LASER INTERFEROMETER GRAVITATIONAL WAVE OBSERVATORY

Document Type	DCC Number	February 28, 2008
	T080050-01-C	
UK PUM Driver Pre-Production Prototype Bench Test and Evaluation		
J. Heefner, T. Etzel

Figure 3: PUM Driver Circuit Board

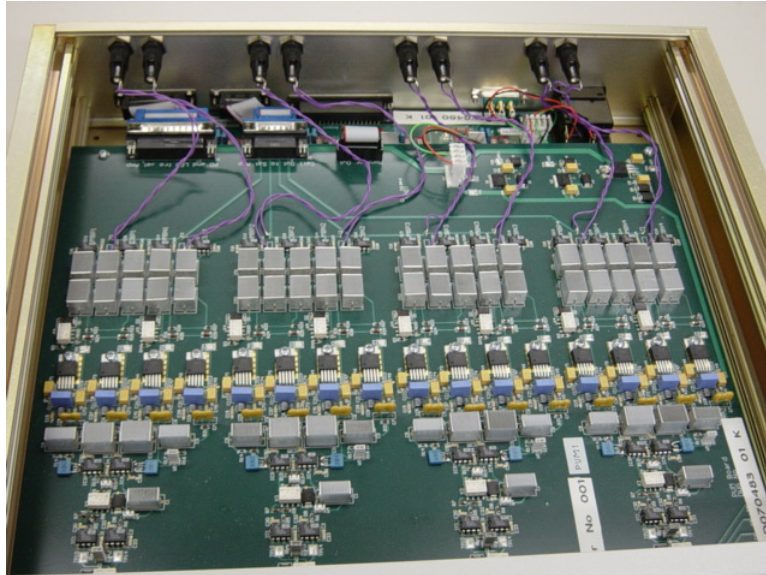
The photo below is a closer view of the PUM Driver board. As can be seen from the picture, the circuit board is multi-layer, professionally manufactured circuit board. The larger silver objects running down the middle of the board are capacitors. Several blue capacitors are installed laying down because they were added to the design following the design of the circuit boards. This is expected in a pre-production prototype, and it is expected that these capacitors will be added to the board design prior to production. These capacitors can be seen more clearly in Figure 4. Additionally, the purple wiring leading from the driver board to the fuseholders mounted on the rear of the chassis is soldered directly into the board and the wires routed to the fuse holders. Prior to production, wire attachment and routing and fuseholder placement should be rethought and if possible, the wires eliminated by using some type of board mounted fuseholder that protrudes from either the front or rear panel of the chassis. This could require a significant amount of board layout and chassis redesign. Each channel of the circuit board flows from the front to the rear of the chassis and appears to have been produced using the multi-channel design features available in Altium. This is a very efficient and convenient way to produce designs that utilize the same circuit topology for multiple channels. When this feature is used, the logical designators for each component in the design are the same since the channel number portion of the physical designator is suppressed on the silkscreen. Therefore, it is very important that the channels be clearly identified and distinguished on the board. This can be done easily by adding lines and channel designation text to the silkscreen layer of the board. It is highly recommended that these lines and text be added to the production design.

The PUM Driver Board is capable of producing currents in excess of 400 mA per channel. The trace widths for these high currents paths appear to be 10-12 mils. Although this may be adequate, it is recommended that these widths be increased to a minimum of 25mils (0.635 mm). In general, it is recommended that all circuit board traces be oversized if possible. Many of the board designs used in AdL will be changed and modified as the project progresses. These design changes will require component changes and board rework and larger traces are less prone to damage.

Figure 7: Close-up View of Power Wiring and Connectors

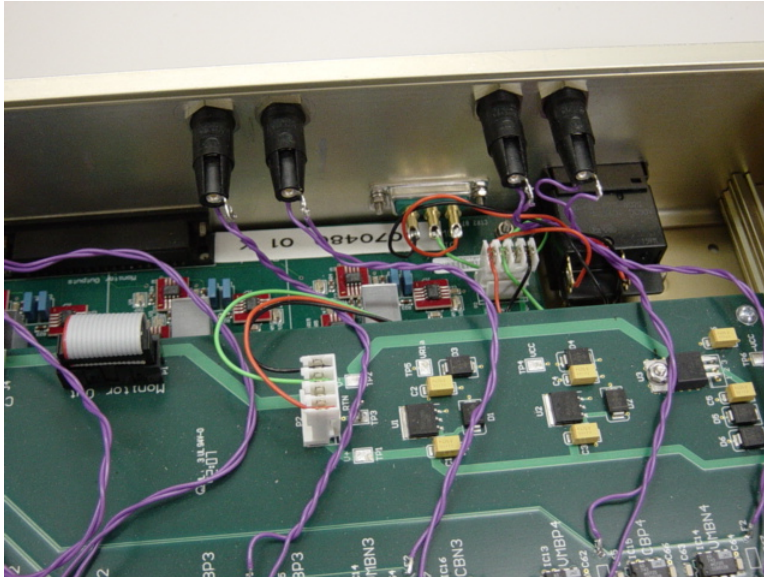
The photo below is a closer view of the input power connections and chassis power wiring. As can be seen from the picture, the solder connections to the rear mounted power connectors are not adequate and wire colors used do not follow the LIGO power wiring color code. In this case, the positive voltage, return and negative voltage wire colors should be white, black and green, respectively. Heat shrink should be included over the power connector pins to prevent inadvertent shorting of the pins. Additionally, the Molex connectors used for connection to the header are the

IDC style without the retaining clip installed. It is strongly recommended that these connectors be replaced with the crimp pin version.

Figure 8: PUM Driver Output Noise

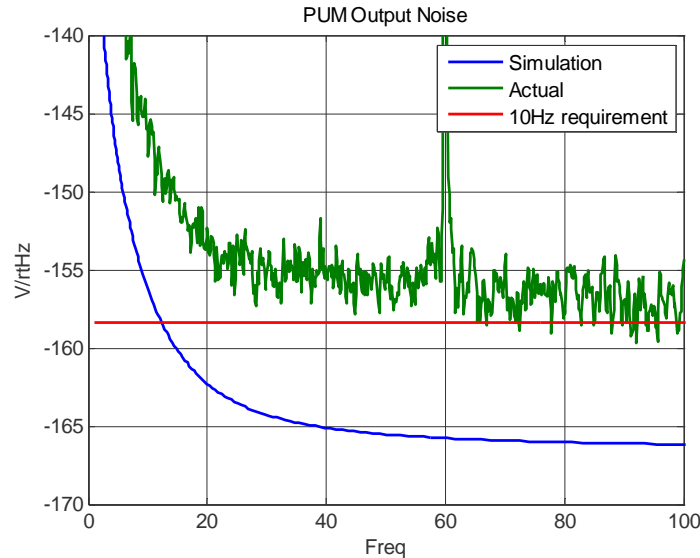
Note that the simulation predicts that the design submitted by the University of Birmingham is slightly worse than the requirement, $15.8 \text{ nV}/\sqrt{\text{Hz}}$ instead of $12.1 \text{ nV}/\sqrt{\text{Hz}}$ at 10 Hz. The measured noise (green) is approximately 12 dB higher than the requirement at 10 Hz. This may be due to difficulty in making the sum and difference noise measurement described in the test plan or it may be that the noise is higher than predicted by the simulation. In either case, this needs to be investigated further once the design of the driver has been finalized (see comments in the dynamic range section of this report, section 4.1.3).

Figure 9: PUM Driver Response (Low Noise Mode)

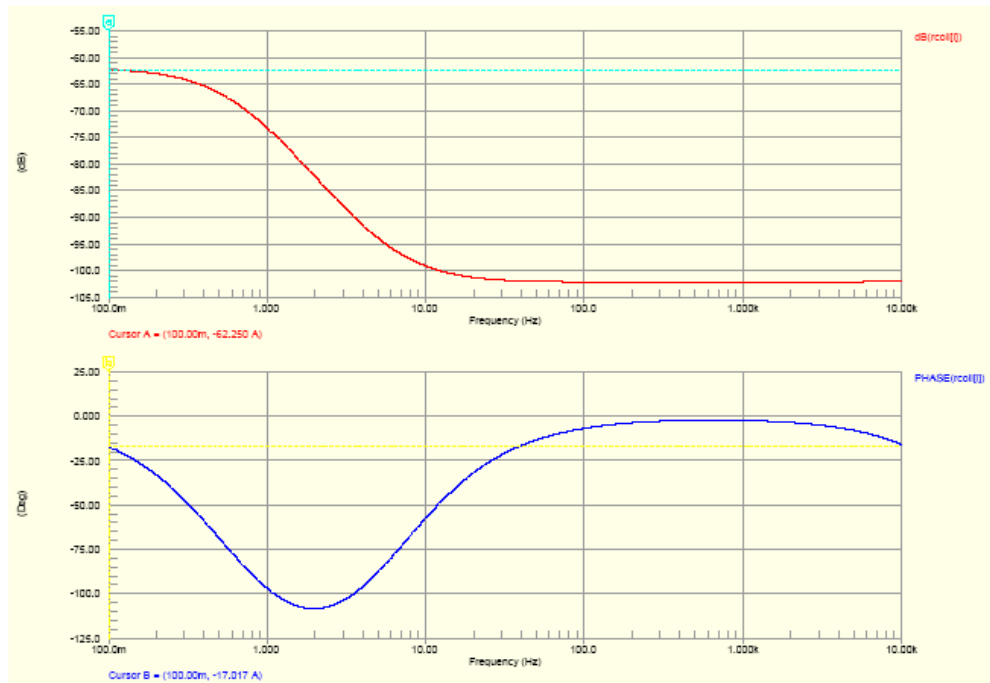
Testing confirmed that measured response and simulated response were very similar for the low noise mode of operation; however there were deviations in the measured response and simulated response for the high dynamic range mode of operation for frequencies above 1KHz. This is likely due to the capacitors added around R12 and R13 which were not included in the simulation. The high dynamic range response is achieved by energizing relays K4 and K5. Energizing these relays adds a zero at 2Hz and pole at 145Hz to the response of the driver. This large separation in the zero/pole pair violates the order of magnitude switching requirement called out in section 2 of the requirements document (T060067). This portion of the circuit will need to be redesigned to meet the requirements.

As was stated in the previous section of this report, the stage preceding the output stage will need to be redesigned. Once this has been done, and the output mode switching has been changed, transfer function tests on the new design will need to be repeated.

Figure 10: Noise Monitor Transfer Function, Measured from Driver Input to Monitor Output

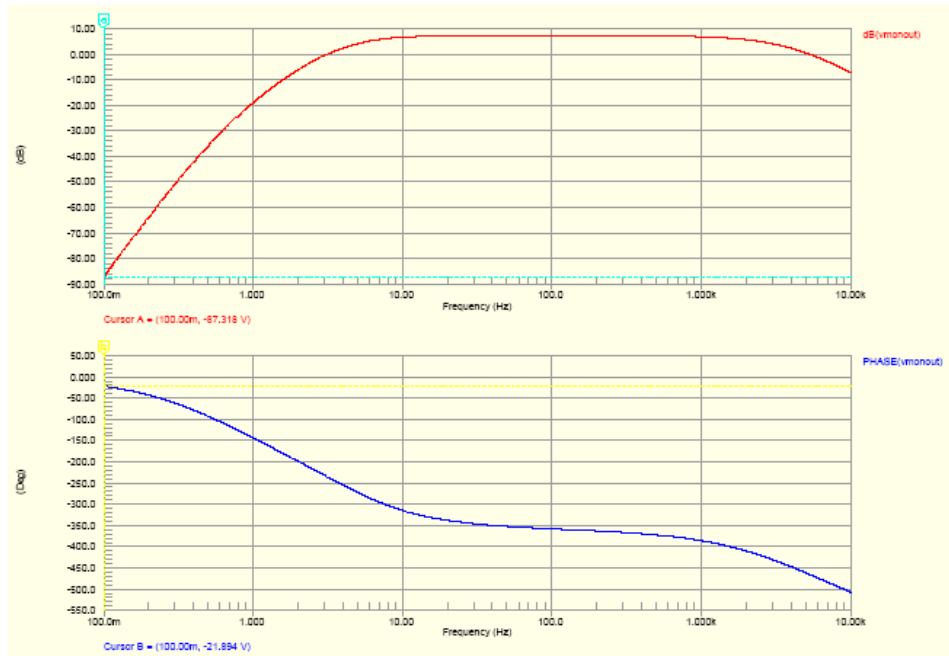
The measured transfer functions for all four channels were found to be in close agreement with the Altium simulation, but as was previously stated in section 4.1.2 of this report, the noise monitor circuit needs to be redesigned to measure the full output noise of the driver at 10Hz. Once the circuit has been redesigned, the transfer function tests will need to be repeated.

Figure 11: Typical Cross Coupling Measurement Results

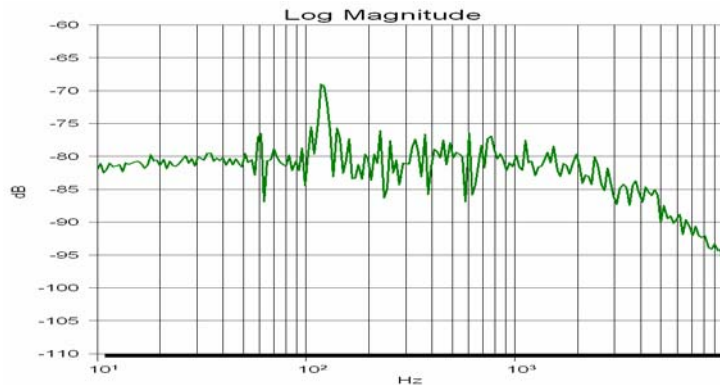
As can be seen from the plot, the highest coupling measured was approximately -80dB above 10Hz. The gain of the noise monitor above 10Hz is greater than 40dB. This leads to an isolation of approximately 120dB from the input of one channel to the output voltage of another channel on the board. This should be acceptable for AdL. Note that the peak seen at 120Hz is most likely a line harmonic, not cross-coupling and was therefore ignored.
